REVISED RESPONSE TO REQUEST FOR ADDITIONAL INFORMATION

APR1400 Design Certification

Docket No. 52-046

RAI No.:	**356-7881**
SRP Section:	**07 – Instrumentation and Controls – Overview of Review Process**
Application Section:	**7.0**
Date of RAI Issue:	**01/04/2016**

Figure 7.7-14 I&C System Architecture for the RCC Panel

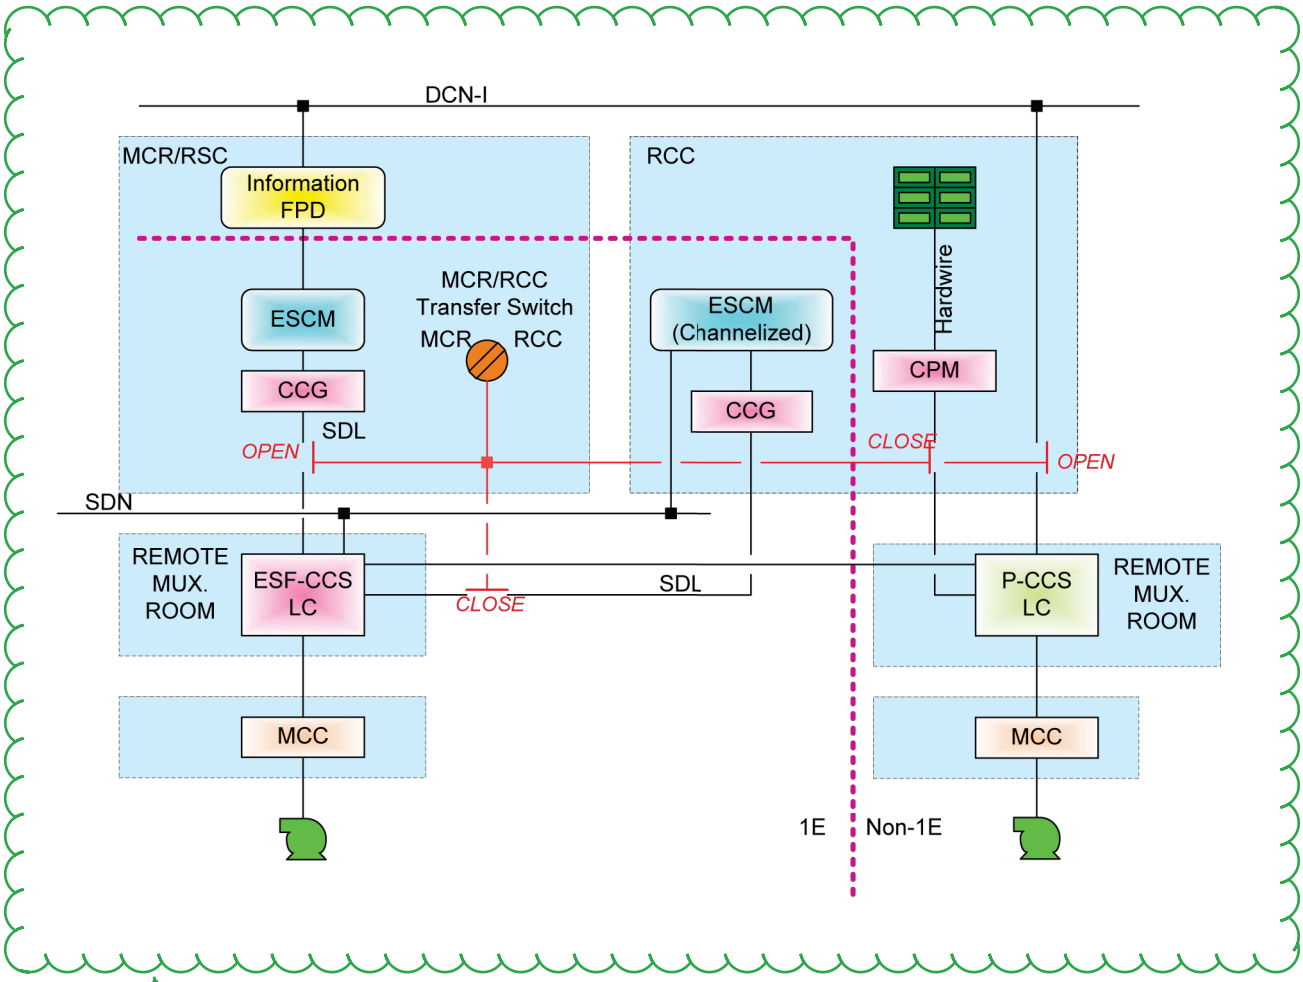
The applicant mentions that the RCC has safety and non-safety related controls available but does not state that RCC complies with any other applicable requirements for this configuration such as independence. The RCC is not depicted on Figure 7.1-1, “APR1400 I&C System Overview Architecture,” therefore, there is no physical depiction of how the functionality of the RCC is taken into account within the overall I&C architecture or how its implemented. The acronym for the remote control center is also not defined in the acronym and abbreviation list in Section 7.0 of FSAR Tier 2. It cannot be determined what the difference is between the RCC and RSR.

1. Describe the RCC including all instrumentation, controls, and displays available at the RCC, all communications and architectural details used to implement the RCC, how the RCC addresses all the applicable requirements to the RCC (i.e. Independence), the specific design functions the RCC is intended to meet, the locations of RCC equipment (i.e. I&C cabinets, if applicable).

DCD Tier 2, Section 7.0, Section 7.7.1.1, Figure 7.1-1, APR1400-Z-J-NR-14001-P/NP, Rev. 0, “Safety I&C System,” Figure 4-1, and APR1400-Z-J-NR-14002-P/NP, Rev. 0, “Diversity and Defense in Depth,” Figure 4-1 will be revised. The depiction of the I&C architecture of the RCC will be added as Figure 7.7-14. DCD Tier 1, Section 2.5.4.1 will be revised to show that the ESCMs on the MCR, RSR, and RCC have same design features, as indicated in the attachment associated with this response.

The I&C system architecture for the RCC panel is shown in Figure 7.7-14.
